Re: Final HPC – 32 Bruin Road

Please find the enclosed Final HPC drawings for building #2 as noted on the approved development plan (DP-12-24-019469).

In addition, below are responses to each of the HPRC comments dated 6/26/2025 and reviewed/discussed at the 6/30/2025 HPRC meeting:

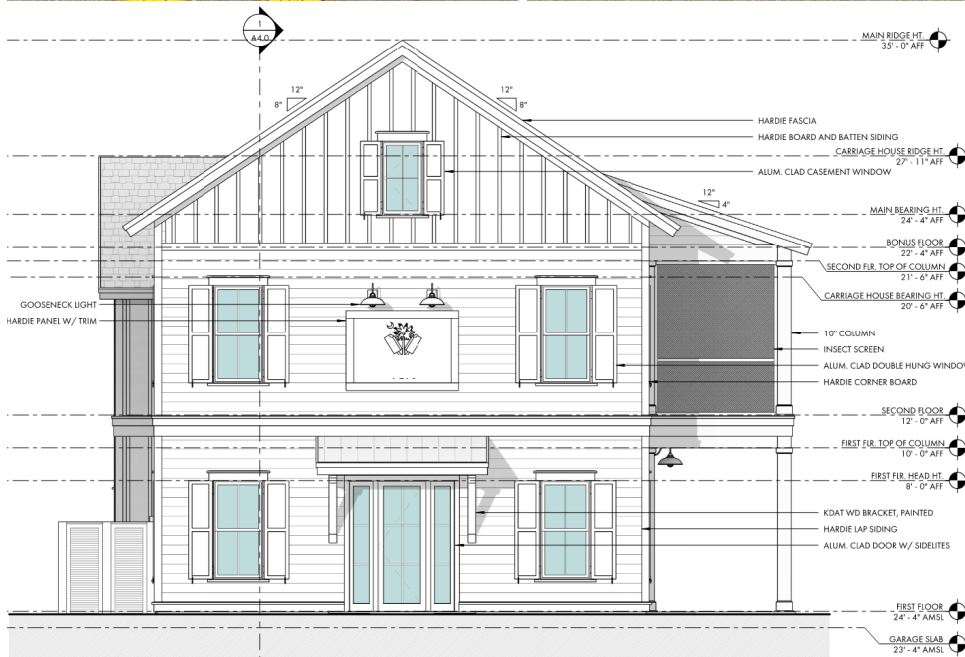
18. (#17) Provide corner and water table details:

- These details have been provided in the Final HPC drawings
